Access Compliance Report

Public Rights-of-Way

(Curb Ramps)

Intersection ID: 51575	Main Street: THRIFT_RD	Cross Street: RUSHING_CREEK_LN	Location: E
ADA ID: 34D4EAA24CAC	Ramp Type: PerpDiag	Initial Pass/Fail: Fail	Overall Compliance: No
Severity Score: 10			
Codes/Mitigation Info/Possible Solution		Field Measurements/Component Compliance

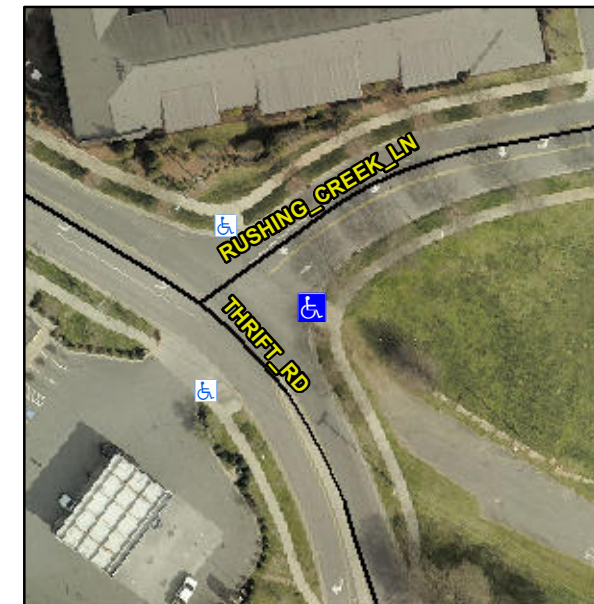
Not Found, R304.5.1, R304.5.3

Compliance	Description	Data	Compliance	Description	Data
N/A	Ramp Length (in)	95.0	Yes	Ramp Slope (%)	5.9
No	Ramp Width (in)	47.5	No	Ramp XSlope (%)	4.5
N/A	Flare Type LT	N/A	N/A	Flare Type RT	N/A
N/A	Flare Slope LT (%)	N/A	N/A	Flare Slope RT (%)	N/A
N/A	Flare Traversable LT?	N/A	N/A	Flare Traversable RT?	N/A
N/A	Landing Length (in)	N/A	N/A	DWS Provided?	N/A
N/A	Landing Width (in)	N/A	N/A	DWS Contrast?	N/A
N/A	Landing Slope (%)	N/A	N/A	DWS Length (in)	N/A
N/A	Landing X Slope (%)	N/A	N/A	DWS Full Width?	N/A
N/A	Landing Curb? (Y/N)	N/A	N/A	DWS Offset (in)	N/A
N/A	Shared Landing?	N/A			
N/A	Gutter Ponding?	N/A	N/A	Gutter Slope (%)	N/A
N/A	Gutter Lip Ht (in)	N/A	N/A	Gutter X Slope (%)	N/A
N/A	Painted X Walk1?	No	N/A	Painted X Walk2?	No
	X Walk 1 Direction	To NW		X Walk 2 Direction	To SW
N/A	X Walk 1 Width (in)	N/A	N/A	X Walk 2 Width (in)	N/A
	X Walk 1 Slope (%)	2.7		X Walk 2 Slope (%)	0.5
	X Walk 1 X Slope (%)	2.7		X Walk 2 X Slope (%)	3.4

Remove & Replace Curb Ramp With Two New Directional Ramps or Equivalent.
